Iredell-Statesville Schools
WAN Connectivity - Request for Proposals (RFP)
FY 2027 E-rate Form 470 Application # 270000665

Wide Area Network (WAN) Connection For Two New Construction Schools

APPENDIX A
SCHOOL SITE PLANS AND FLOORPLANS

PARTIAL ELECTRICAL SITE
PLAN WITH PATH FOR
IFO/OFO TO DEMARC IN
MEDIA CENTER

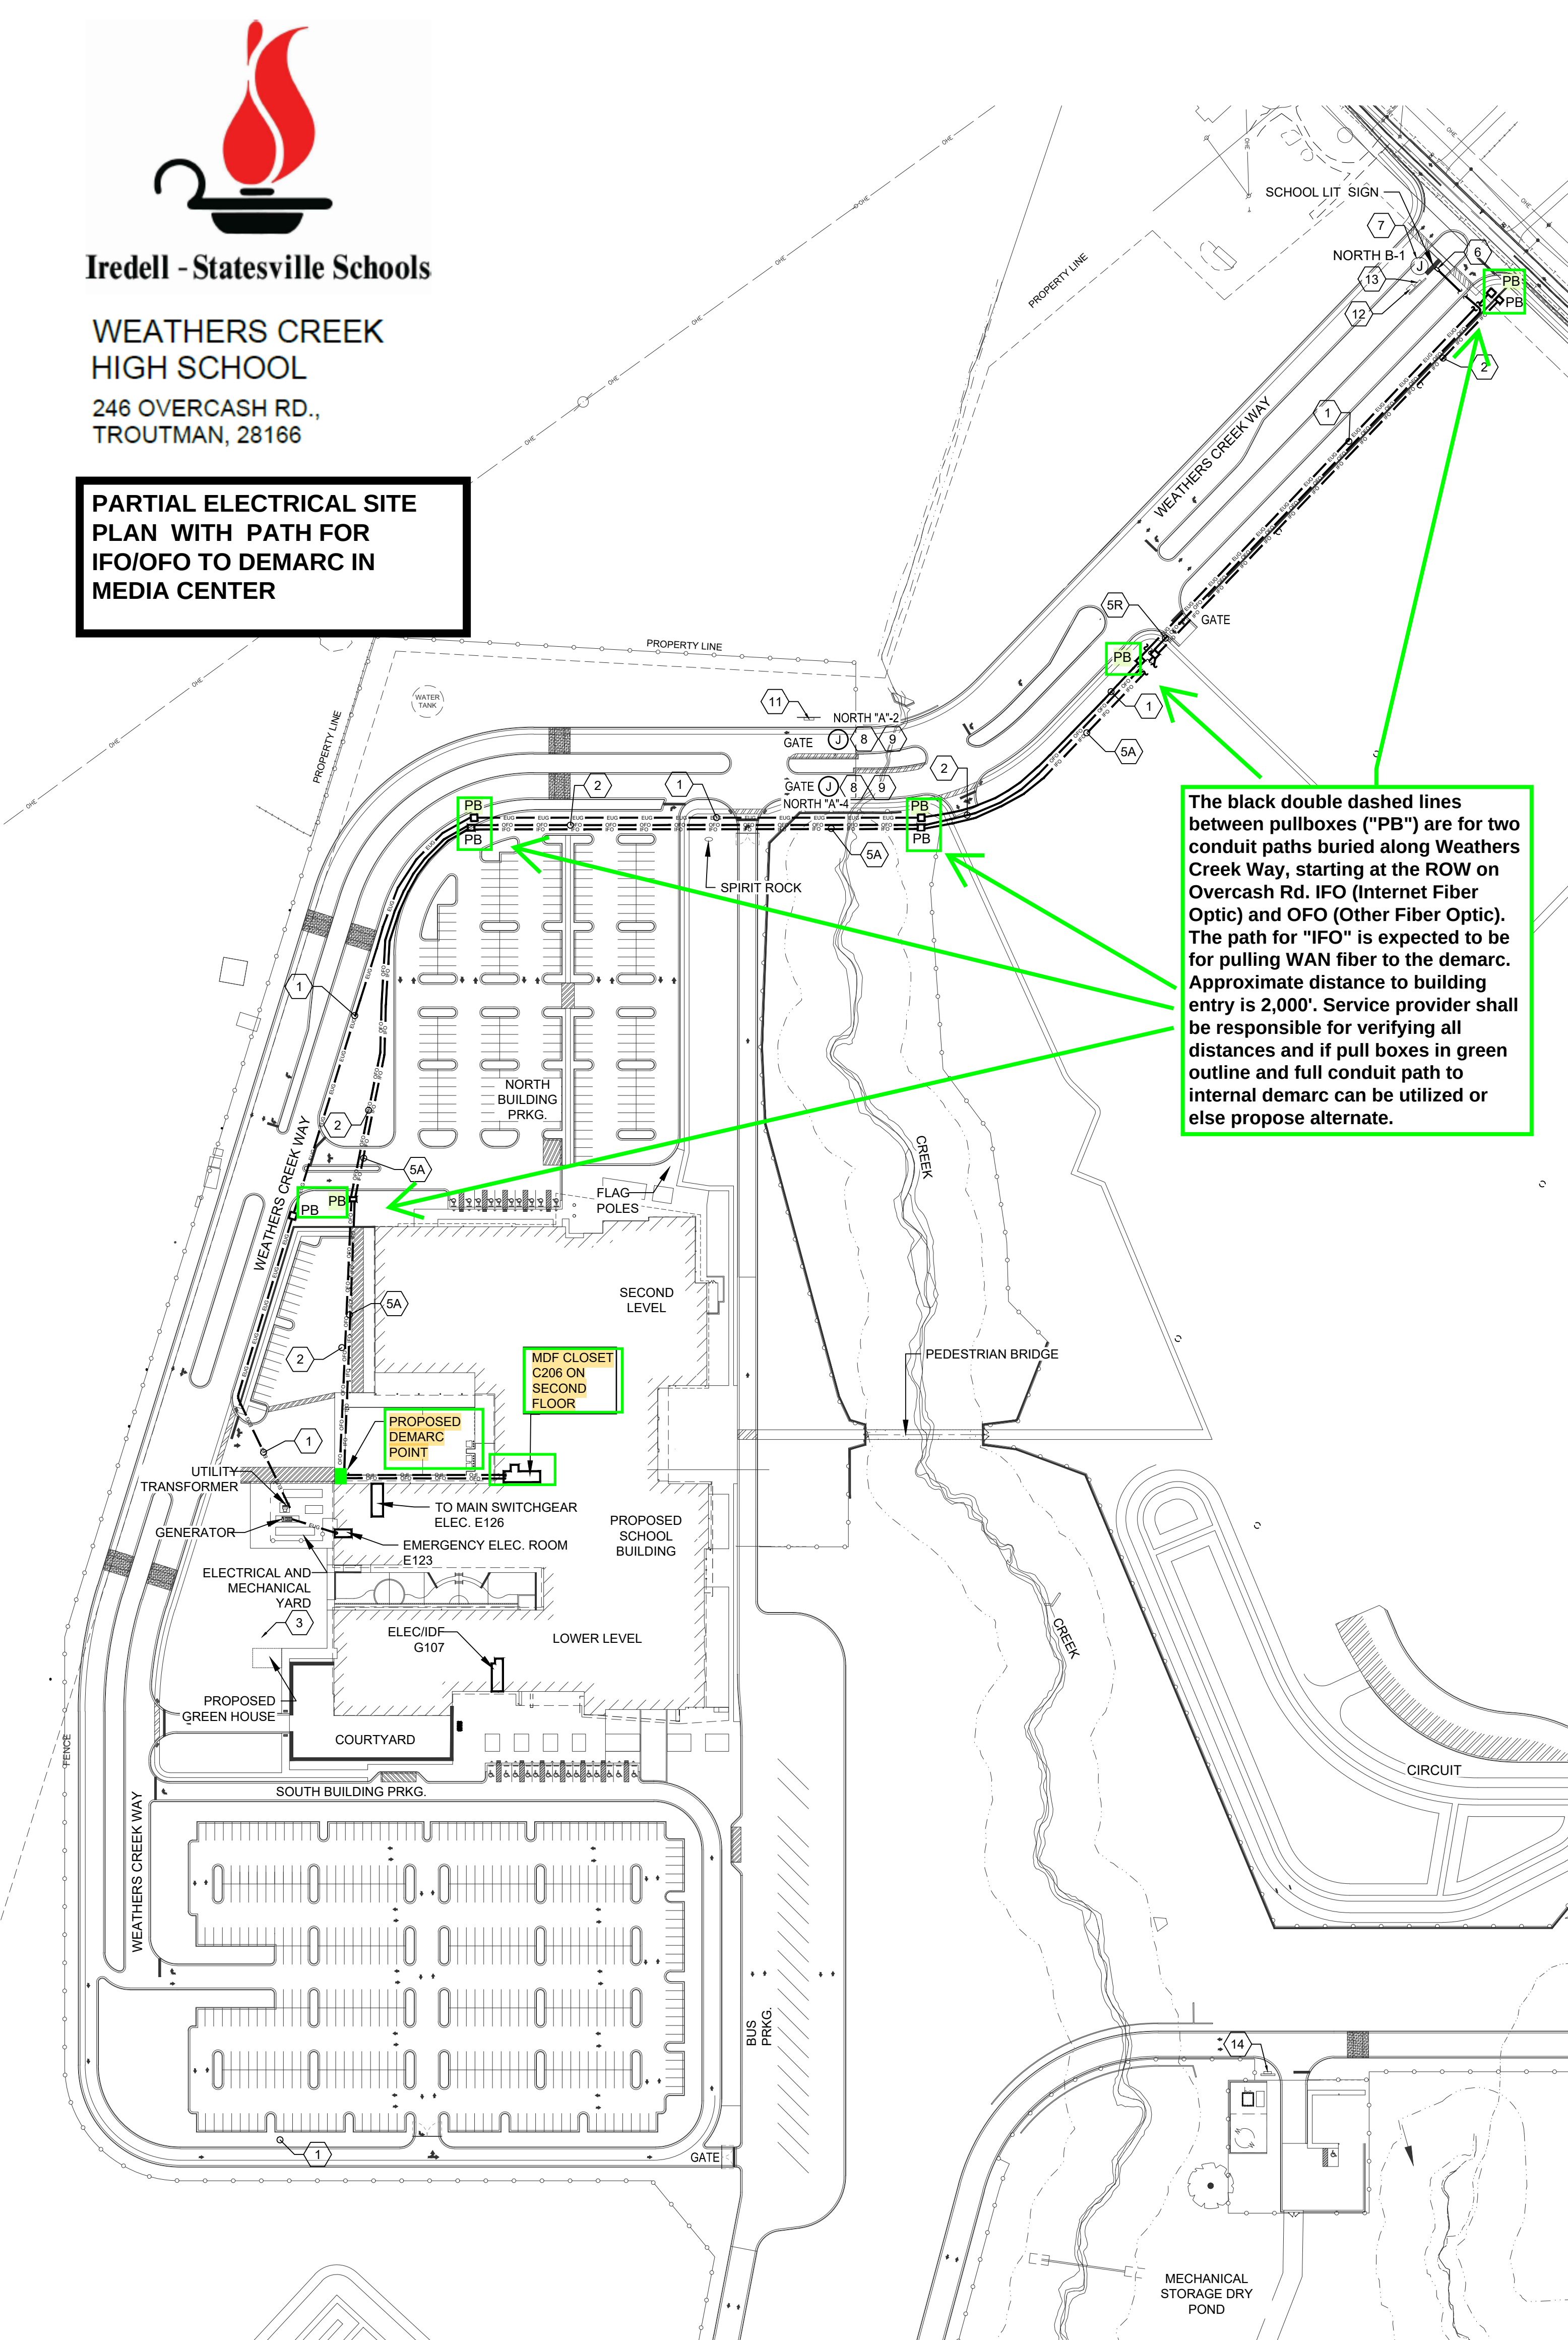
See the black double dashed lines between pullboxes ("PB" in green outline indicated by the narrative arrows). These are for two conduit paths buried along the southern side of Weathers Creek Way, starting at the ROW on Overcash Rd. The small inline print shows IFO (Internet Fiber Optic, presumably) and OFO (Other Fiber Optic, presumably) on each line. The path for "IFO" is expected to be for pulling WAN fiber to the demarc. Approximate distance from Overcash Road to demarc/conduit entry (small green rectangle at end of school wing) is 2,000'. Service provider shall be responsible for verifying all actual distances and if pull boxes in green and full conduit path to external MPOE and/or internal demarc are compatible and can be utilized, or else shall propose an alternate route.

See MDF closet location in the building. This corresponds to the electrical system drawing, 2nd level drawing on the next page for the Media Center "Head End". Note that the MDF and "proposed demarc point" are not adjacent. The marked demarc point may be the actual MPOE and therefore a demarc extension of approximately 180-200' may be necessary to reach the MDF. This will be clarified upon the site visit and RFP amendment posting.

The black double dashed lines between pullboxes ("PB") are for two conduit paths buried along Weathers Creek Way, starting at the ROW on Overcash Rd. IFO (Internet Fiber Optic) and OFO (Other Fiber Optic). The path for "IFO" is expected to be for pulling WAN fiber to the demarc. Approximate distance to building entry is 2,000'. Service provider shall be responsible for verifying all distances and if pull boxes in green outline and full conduit path to internal demarc can be utilized or else propose alternate.

1
E4.10C
ELECTRICAL SYSTEM SECOND LEVEL PLAN AREA C
1/8" = 1'-0"

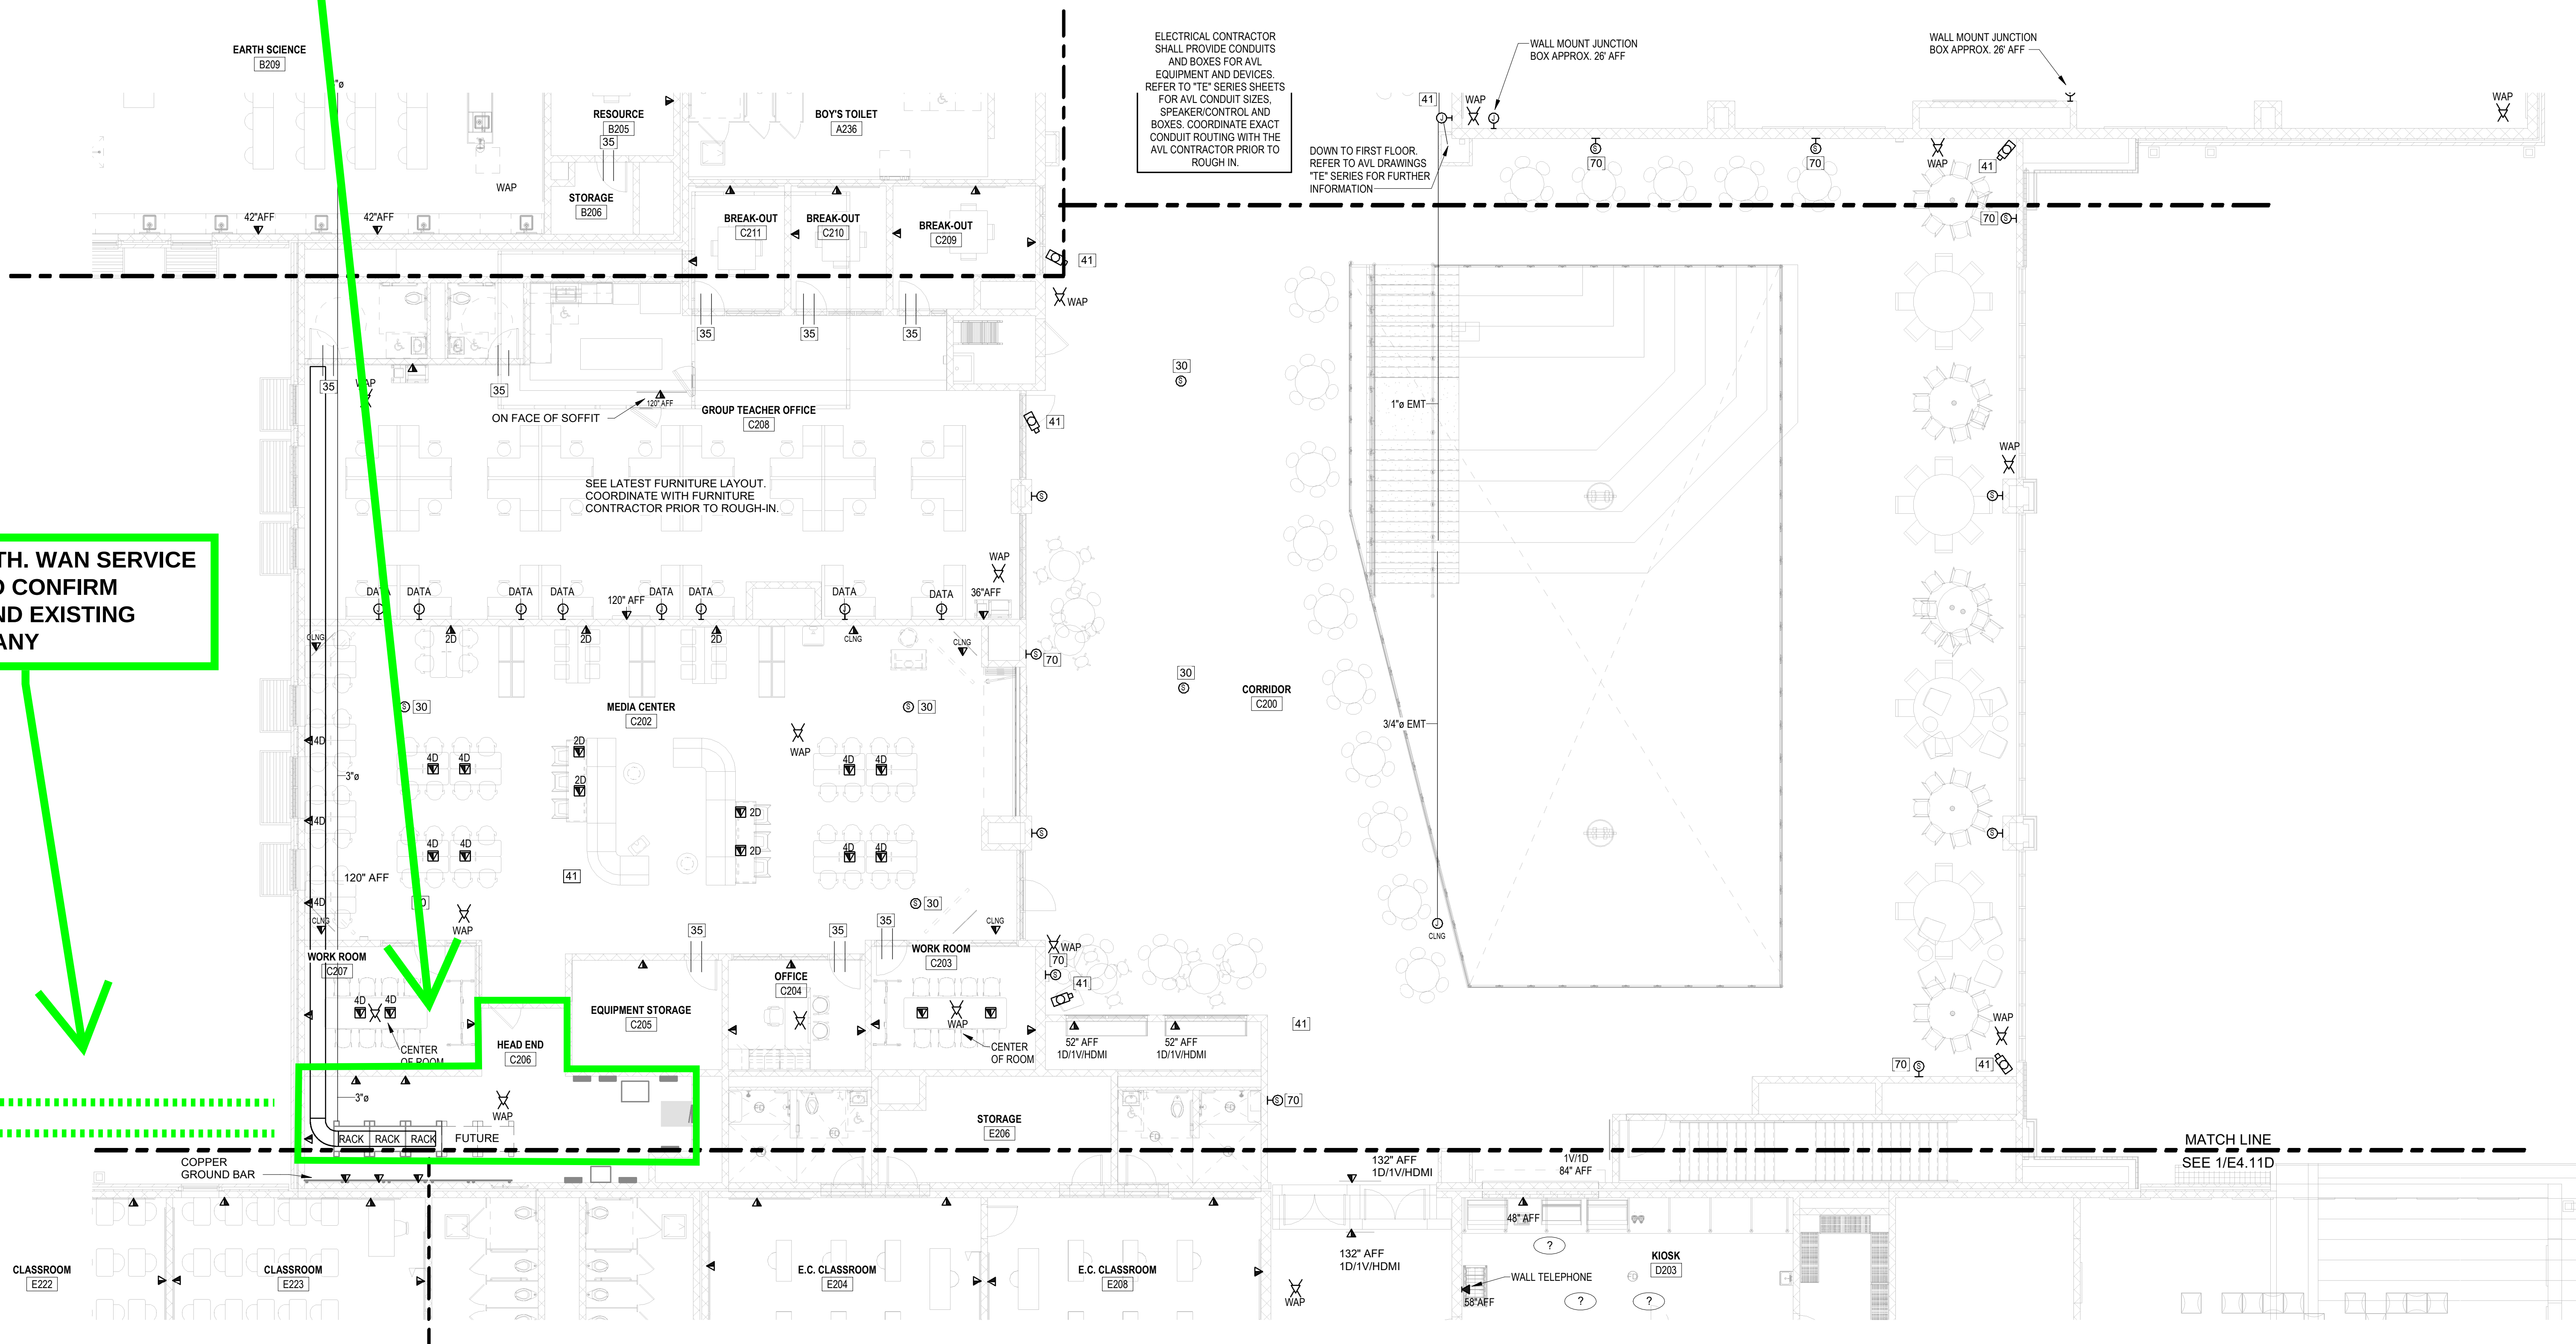
The MDF is in the Media Center "Head End" at the drawings lower left corner, room C206. This is on the 2nd floor, but the lot is sloped so this is near grade to the left (west) side of the building. If the service provider can bring MPOE to the media center instead of demarc at the end of the wing on the previous drawing, the service provider must confirm this path via the "IFO" conduit run on this drawing and previous page siteplan with the general contractor or district staff, preferably during the scheduled site visit. Otherwise this will be clarified via the RFP amendment posting.

DEMARC IN MEDIA CENTER, HEAD
END RM C206. (2ND FLOOR)
SERVICE PROVIDER MUST
CONFIRM PATH VIA 'IFO' ON
SITEPLAN WITH GENERAL
CONTRACTOR, OR AT SITE VISIT
OR VIA RFP AMENDMENTS
THEREAFTER

IFO / OFO PATH. WAN SERVICE
PROVIDER TO CONFIRM
LOCATION AND EXISTING
CONDUIT, IF ANY
